Review of Proposed Sewage Works

Lot 28, Concession 9, Wahwashkesh Lake, Municipality of Whitestone, ON

Pinchin File: 318638

LEGEND

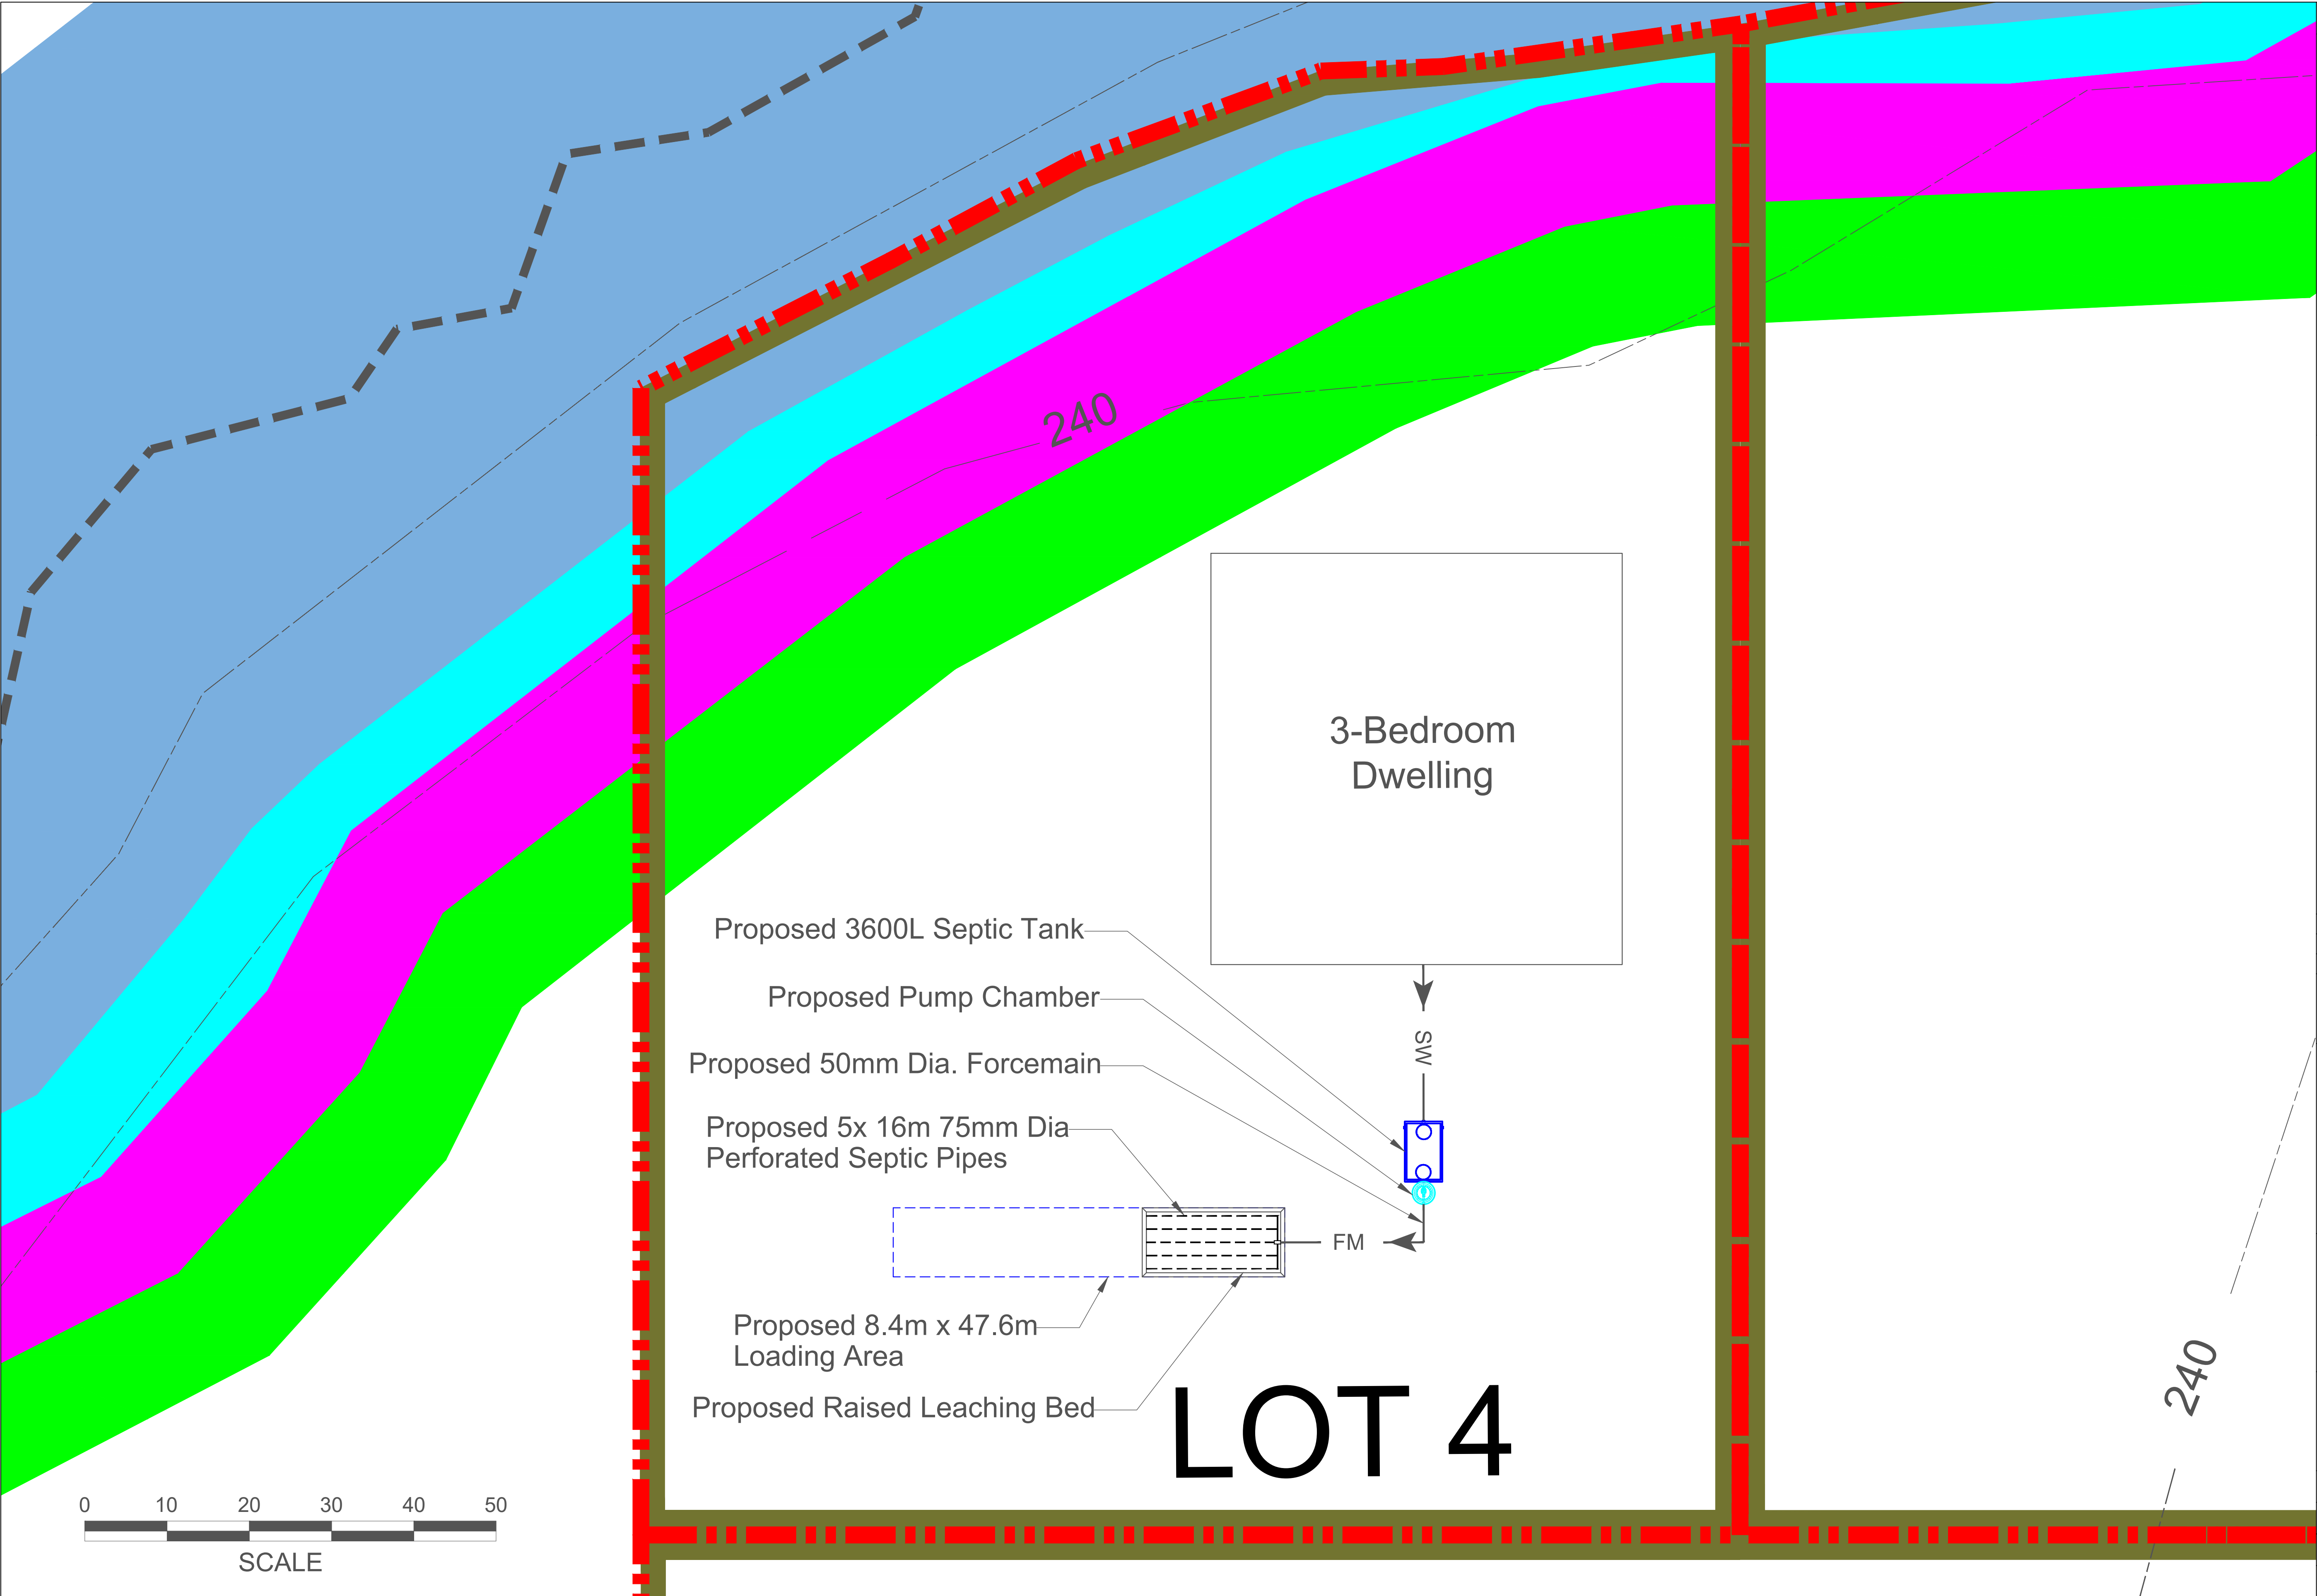
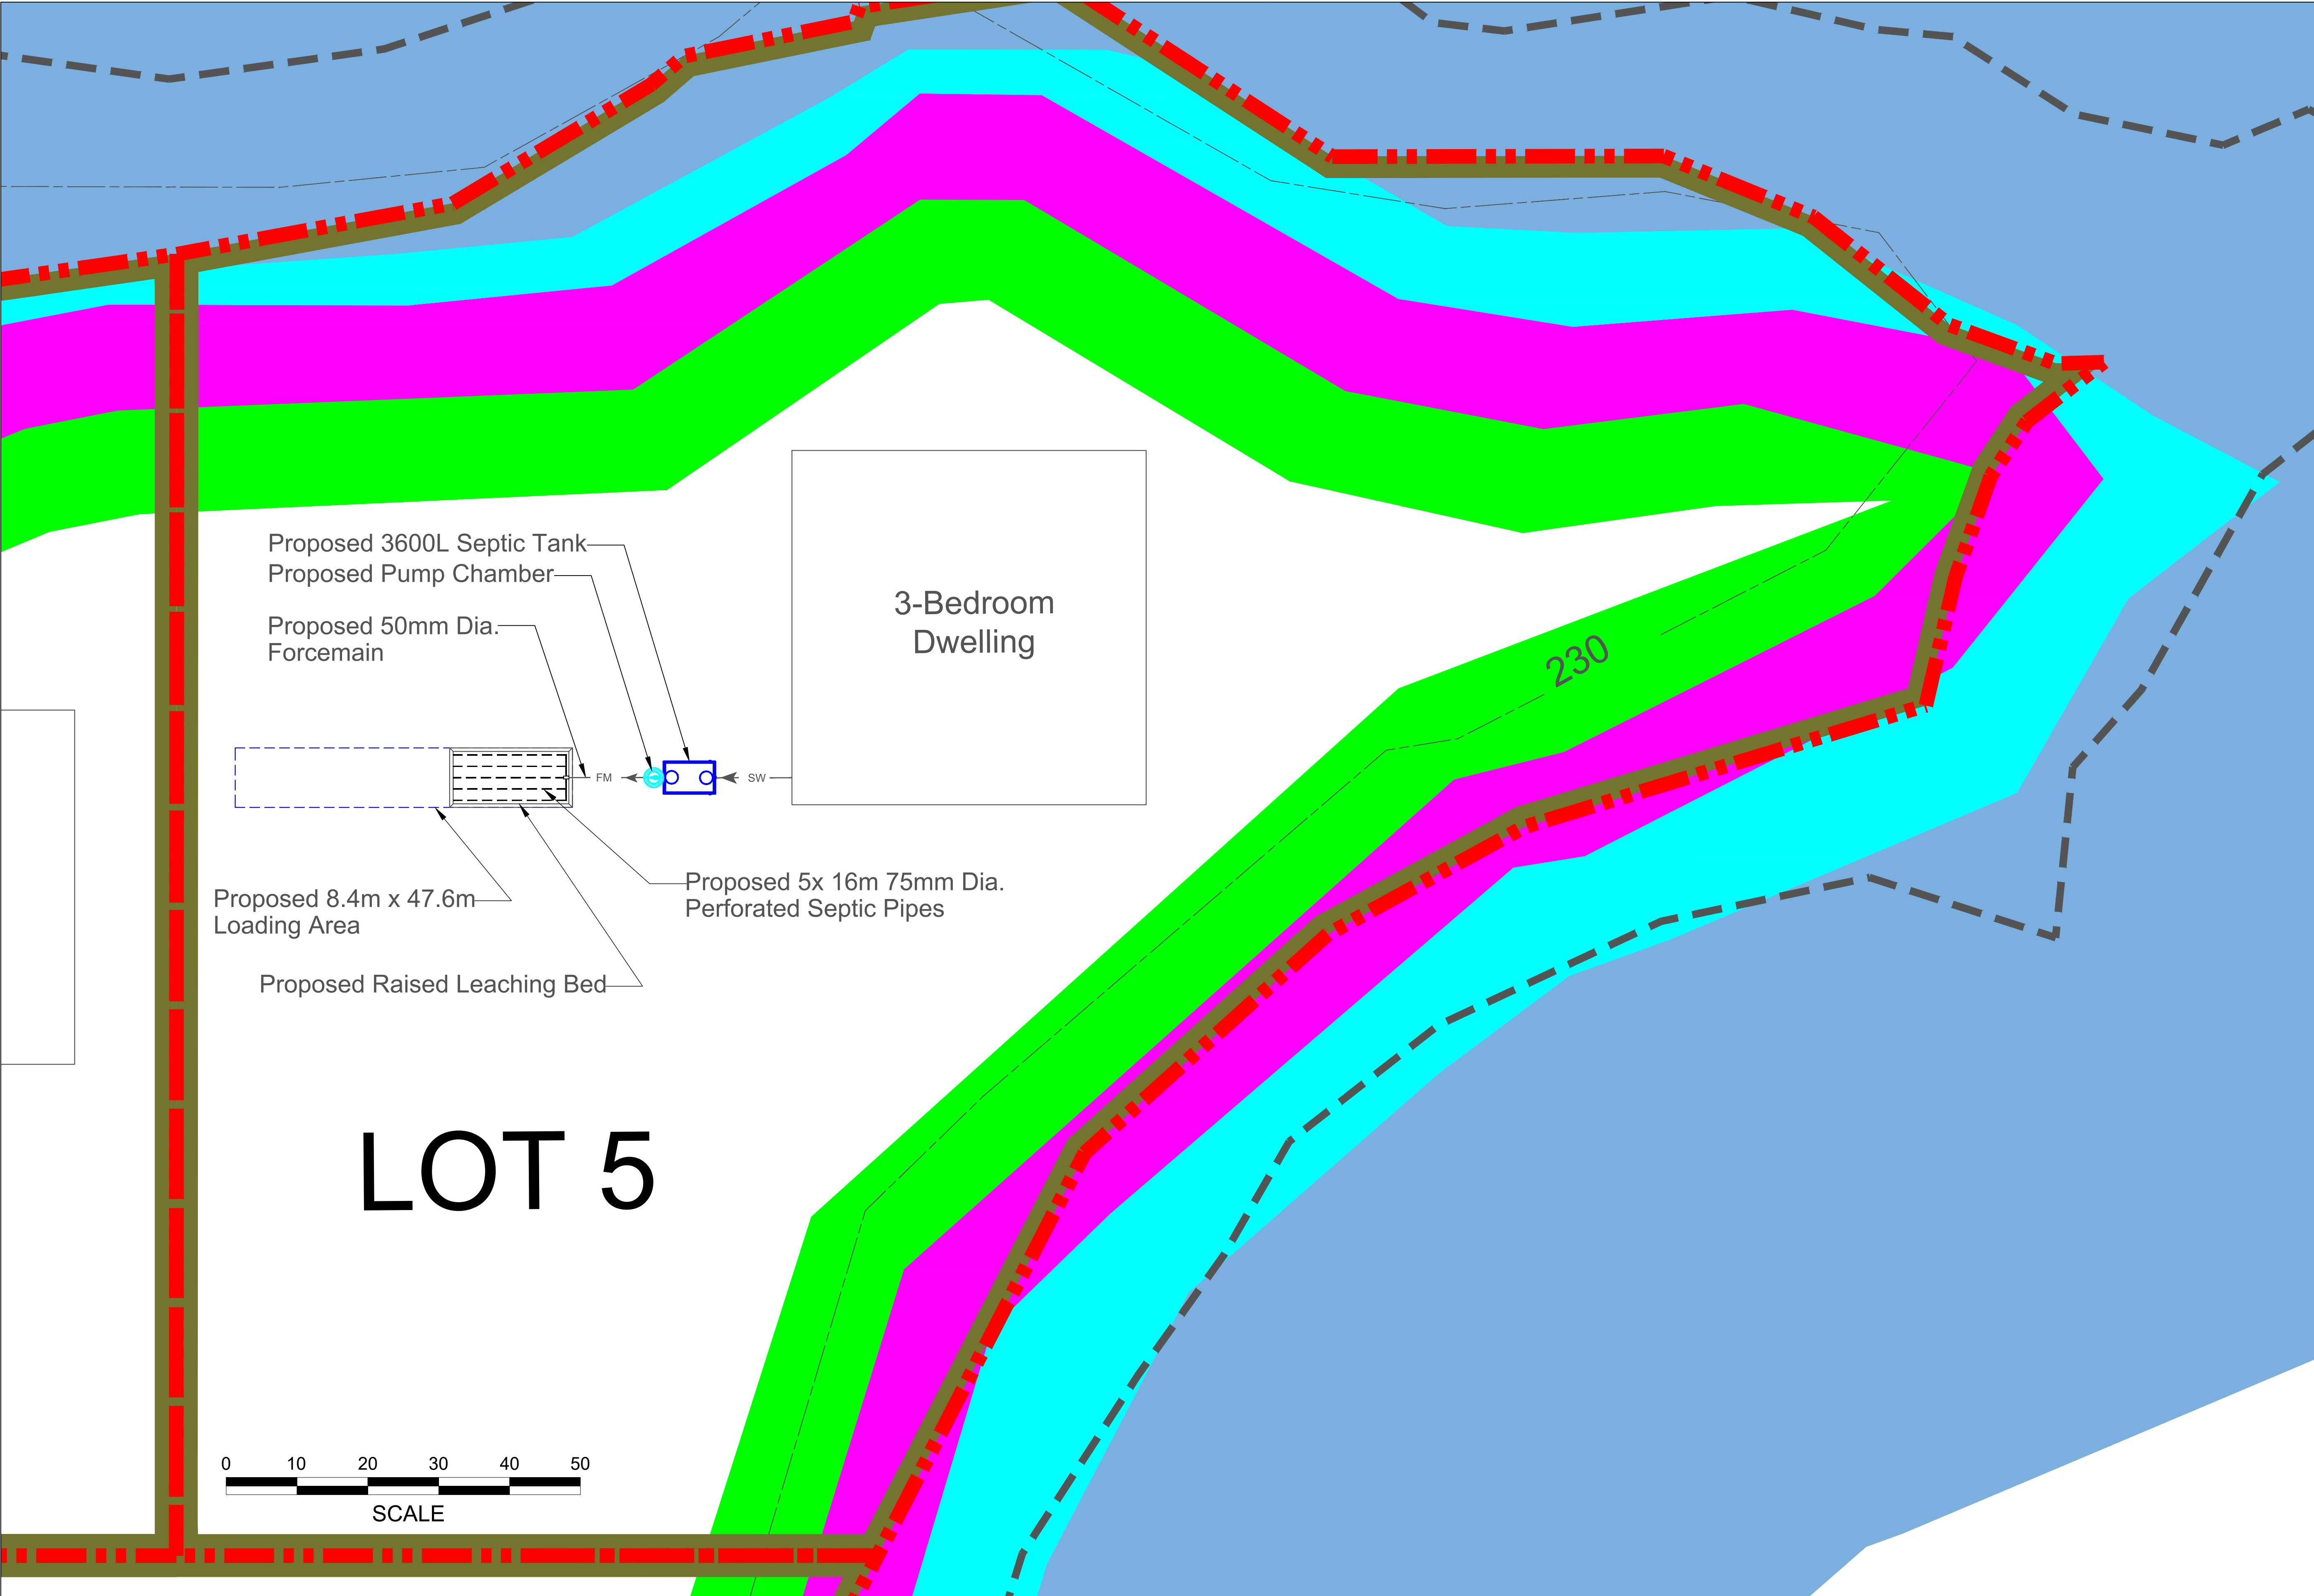
See Appendix III for conceptual layouts for a three (3) bedroom and five (5) bedroom dwelling with associated sewage works.

1. The sewage works only be construction in locations with a minimum starting elevation of 229.57masl and be setback from this elevation so that they,<the sewage works>, meet the minimum requirements of the OBC and the Whitestone Septic Policy. This will allow the sewage works to avoid the high-water level, thus meeting the requirements of the OBC, and maintain proper operation in the event of a flood; and
2. For all lots, determine the maximum footprint and occupancy (no. of bedrooms) of the proposed dwellings that will allow the sewage works to be installed such that they meet the requirements and setbacks of the OBC of the Whitestone Septic Policy.
